C1980007, West Elk Mine, TR-149, Second Adequacy Review

Re: West Elk Mine (Permit No. C-1980-007)
Technical Revision No. 149, (TR-149)
Second Adequacy Review

Figure 1: Projected E-Seam overburden over LWE-14

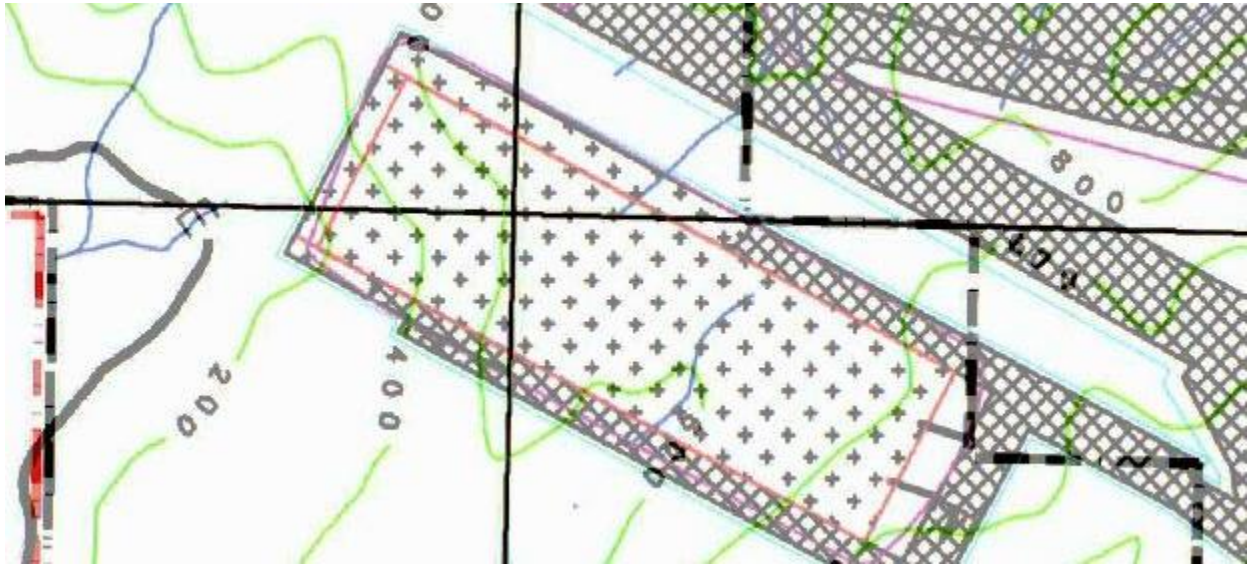
4. *[Updates to Map 51]*
The response is sufficient
5. *[Updates to Map 19]*
The response is sufficient
6. The updated versions of Maps 51 and 19 can be overlain on each other to show the projected depth of cover over the projected E-seam mine workings. Screenshots of small areas of these overlain maps are included below as figures 1 and 2.

Figure 1 shows that the projected depth of cover at the southwest corner of panel LWE-14 is approximately 200 feet.

WWE recommendations in Exhibit 60E, are that longwall mining height be reduced under shallower depth of cover to allow for a 20% factor of safety, but WWE “do not recommend that longwall mining occur where overburden thickness is not at least 250 feet, even with reduced mining height.”

Please provide a detailed description of the mine plan for panels LWSS4 and LWE-14, consistent with the recommendations in Exhibit 60E. This should be included in the text of section 2.05.6(6)

Figure 2: Projected E-Seam overburden over LWSS3 and LWSS4

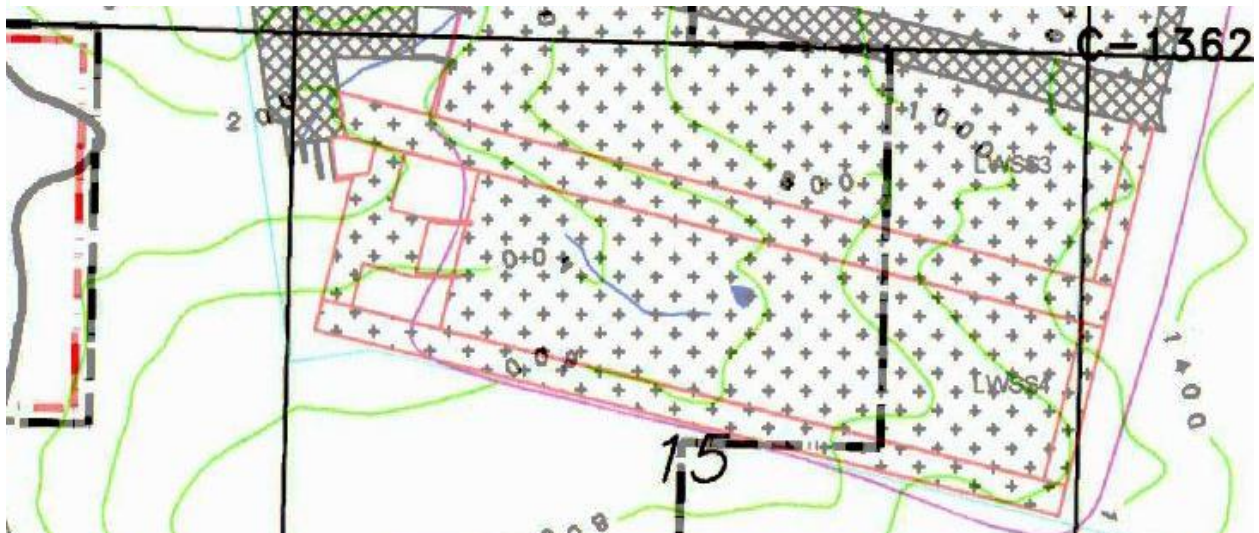
Figure 2 shows that the projected depth of cover at western end of panel LWSS4 may be less than 300 feet.
